1199 Panigale Safety Upgrades
Models: MY 2012 and MY 2013 Panigale (All Versions)
Recall Bulletin RCL-12-006

Date: Tuesday, August 7th, 2012
To: Dealer Principal, Service Manager, North American Dealer Network
From: Austin Gray, Technical Director; Jonathan LaForte, Technical Manager

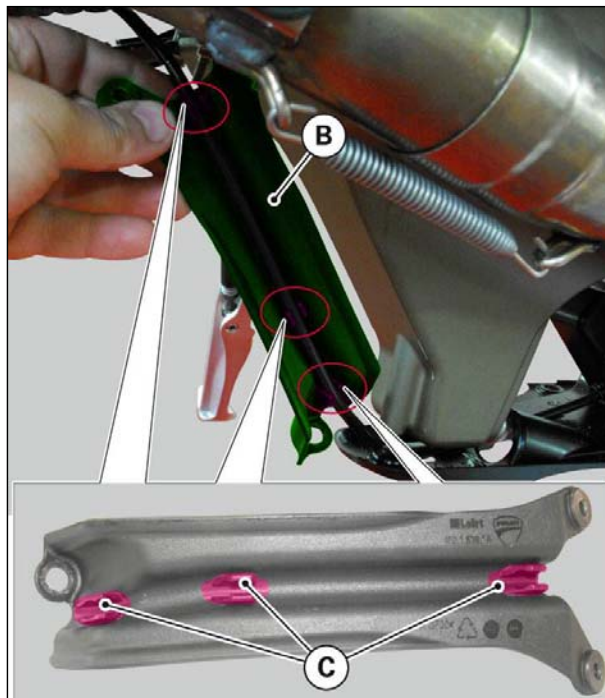
- 8) Release the exhaust butterfly valve cable from the clips of the **exhaust butterfly valve Bowden cable support (A)** and remove the latter.

- 9) Install the new **exhaust butterfly valve Bowden cable support (B)** part no. 46015393A and engage the cable inside the **three clips (C)**.

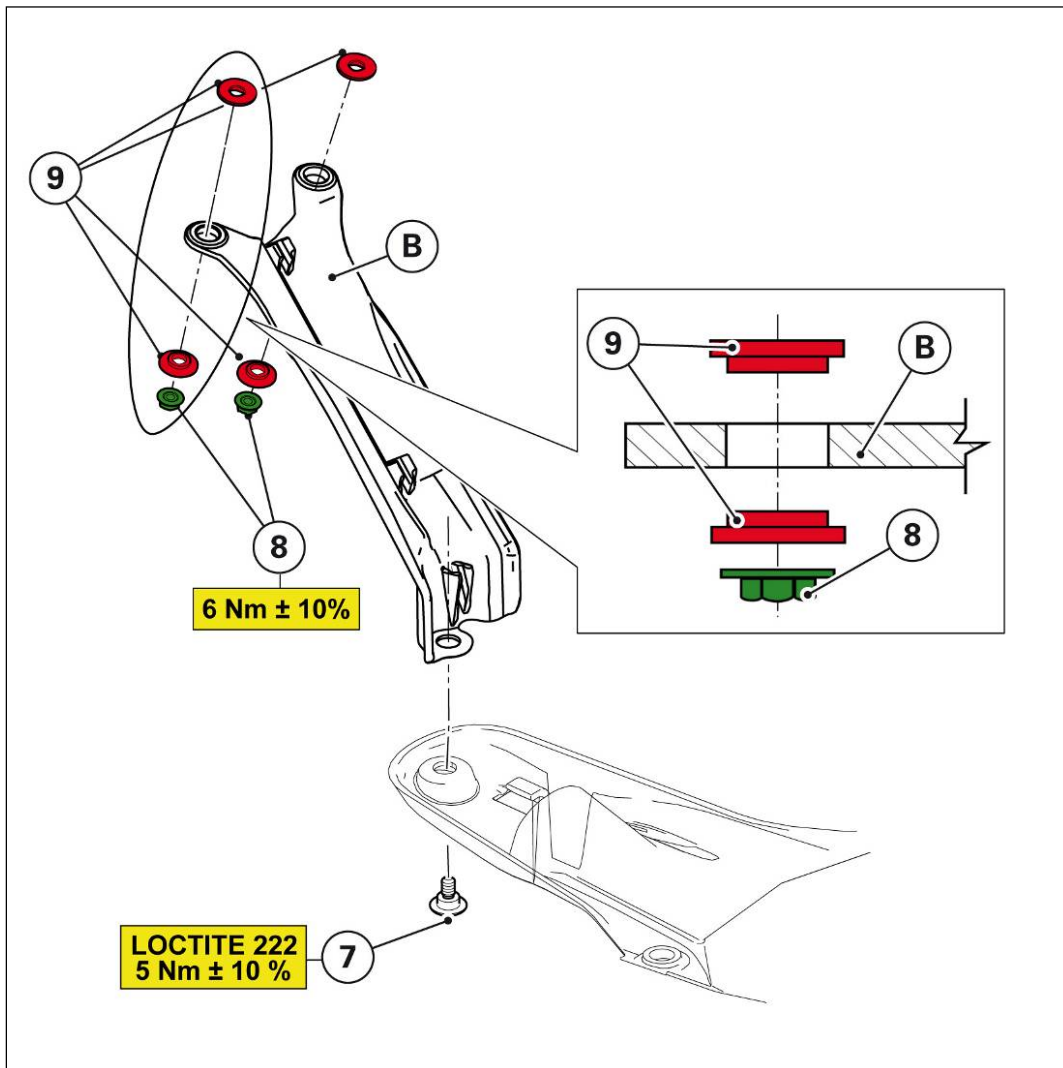
- 10) Fit the new exhaust butterfly valve Bowden cable support (B) part no.46015393A and tighten the **bottom screw (7)** to **$5\text{ Nm} \pm 10\%$** after applying **LOCTITE 222** , then tighten the **two top nuts (8)** to **$6\text{ Nm} \pm 10\%$** .

Fit the four **spacers (9)** correctly, as shown below.

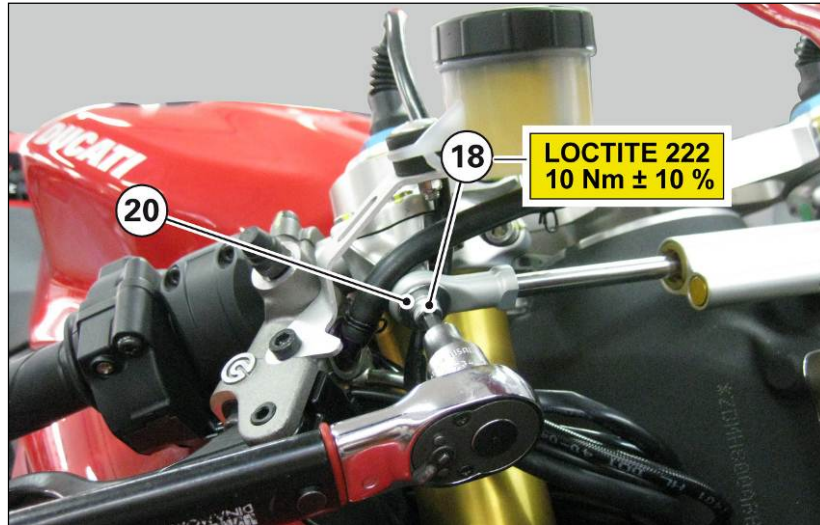
- 3) Remove the **screw (18)** retaining the **steering damper (19)** to the right-hand handlebar, remove any trace of threadlocker and thoroughly degrease the surface.
- 4) Start the **screw (18)** with **washer (20)** in-between.

- 5) Tighten the **screw (18)** with **LOCTITE 222** to **10 Nm $\pm$ 10%**.

Washer (20) must be installed only on S versions, i.e., where an Ohlins steering damper is fitted. The washer must NOT be installed on BASE versions equipped with SACHS steering damper.

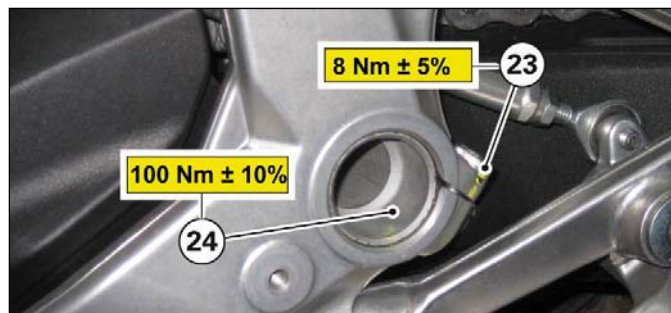
- 1) Loosen the **screw (21)** from clamp on RIGHT-hand swinging arm shaft.
- 2) Loosen the **RIGHT-hand swinging arm shaft (22)** by 180° without removing it.
- 3) Tighten **RIGHT-hand swinging arm shaft (22)** to **100 Nm ± 10%**.
- 4) Tighten clamp **screw (21)** to **8 Nm ± 5%**.

- 5) Slacken the **screw (23)** from clamp on LEFT-hand swinging arm shaft.
- 6) Loosen the **LEFT-hand swinging arm shaft (24)** by 180° without removing it.
- 7) Tighten **LEFT-hand swinging arm shaft (24)** to **100 Nm ± 10%**.
- 8) Tighten clamp **screw (23)** to **8 Nm ± 5%**.

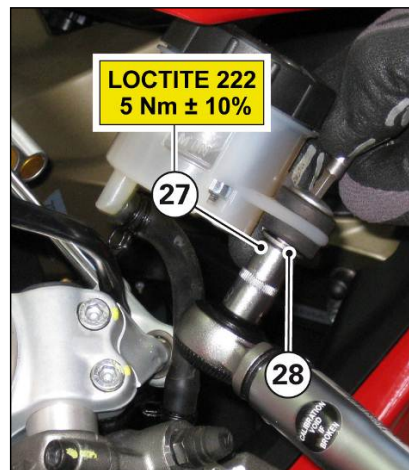
- 1) Remove **nut (25)** retaining the front brake fluid **reservoir (26)**.

- 2) Start the new **cap nut (27)** and add the **washer (28)**. Tighten the **cap nut (27)** with LOCTITE 222 to 5 Nm $\pm$ 10%.
